**RE: Draft Plan of Subdivision SUBP.22.R.0037 (SUB-22-008)
Zoning By-law Amendment ZBA.21.R.0098 (D02-21010)
Lot 24 and Part of Lot 23, Registered Plan 3806
551 & 561 16th Avenue
(Mina Mahroo)
City of Richmond Hill**

York Region has now completed its review of the above noted draft plan of subdivision prepared by Altimap Land Surveyors Inc., Job No. 21-1593, dated August 2, 2022. The proposed development is located on lands municipally known as 551 & 561 16th Avenue, on the southwest corner of Fern Avenue and 16th Avenue, in the City of Richmond Hill. The proposal will facilitate the development of 2 single detached units, 10 semi-detached units and 2 future development blocks to accommodate 2 additional single detached units, within a 0.44 ha site.

MEMORANDUM- TECHNICAL COMMENTS

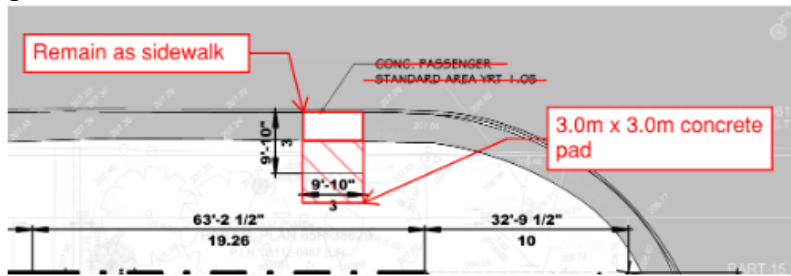
1. The Owner is strongly encouraged to coordinate with the City of Richmond Hill to provide sidewalk facilities along the "Future Public Street" that connect to the municipal network along Fern Avenue.
2. The pedestrian access connection shall meet the local municipality's standards for sidewalks and shall be owned and maintained by the local municipality.
3. Existing YRT transit services operate on the following roadways in the vicinity of the subject lands:
 - 16th Avenue – Route 16

4. Please reference the redlined site plan below for more details regarding bus pad location and design.

5. The passenger standing area shall be constructed at no cost to York Region and shall be provided concurrently with construction of necessary sidewalks connecting the development to transit service.
6. Landscaping should not interfere with the bus stop, passenger standing area, shelter or corner sightlines.
